REVISIONS			
DESCRIPTION			
JA	A	REMOVED WOODEN BLOCK (ECO REF # 020-2015)	04.07.15
JA	B	CHANGED TABLE NOTCH TO 8" x 4"; WAS 7" x 4"(ECO REF # 020-2015)	09.01.15

13760 Midway Street Cerritos CA 90703 562-404-8111 Fax 562-404-7781	
MAKE PICTURE YES		TITLE 2016 KING AIRE 75" x 33" U-DINETTE	
TOLERANCES: DECIMALS 3 PLACE ± 0.005 2 PLACE ± 0.01 1 PLACE ± 0.1 FRACTIONS ± 1/16 ANGULAR ± 1° DO NOT SCALE DRAWING		OR J.ANCHETA 02.20.15 SCALE 1:1 CK DWG. NO. VI4000176 REV. B

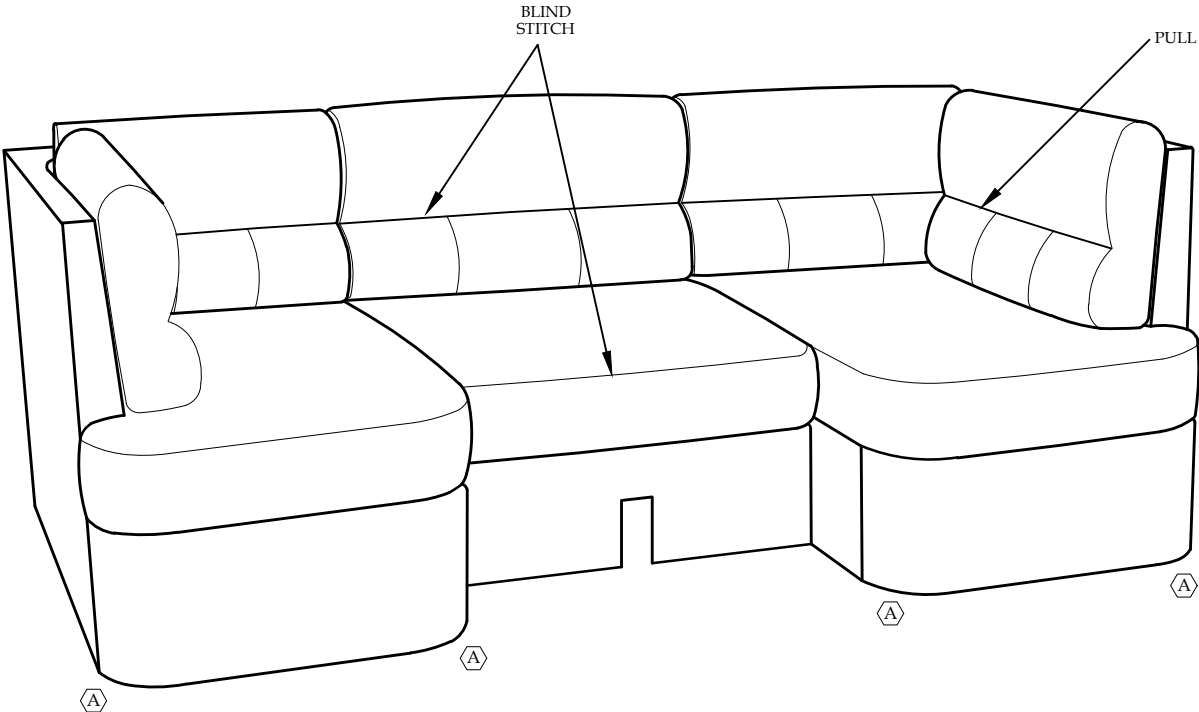
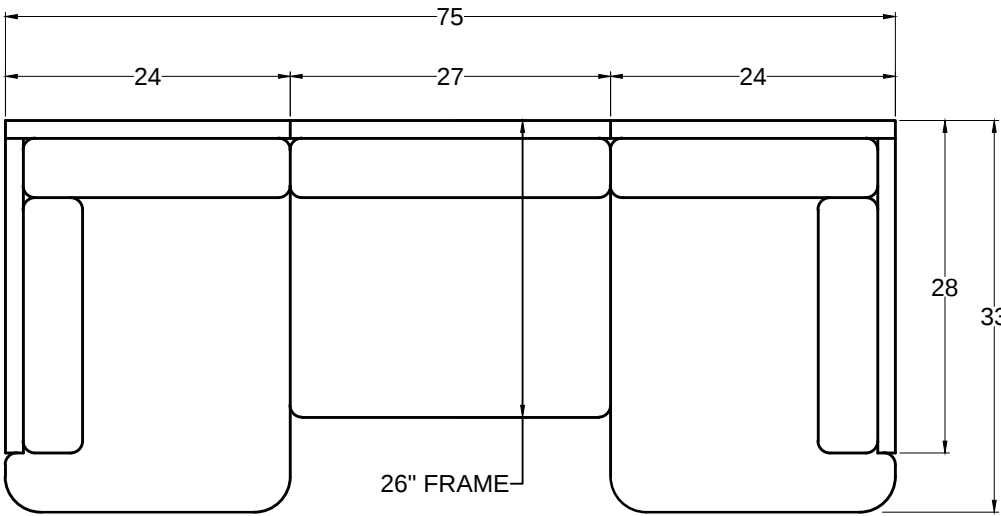
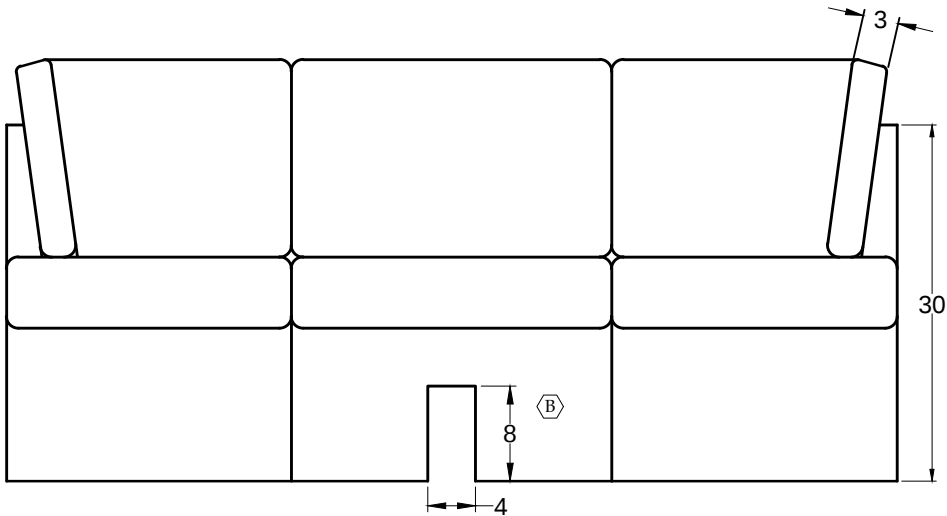
DATE	REQUESTED BY	CHANGE REQUESTED	COMPLETED BY
09.01.15	ROBERT L.	ECO #051-2015 - Table notch too short. Change to 8"h x 4"w.	J.ANCHETA
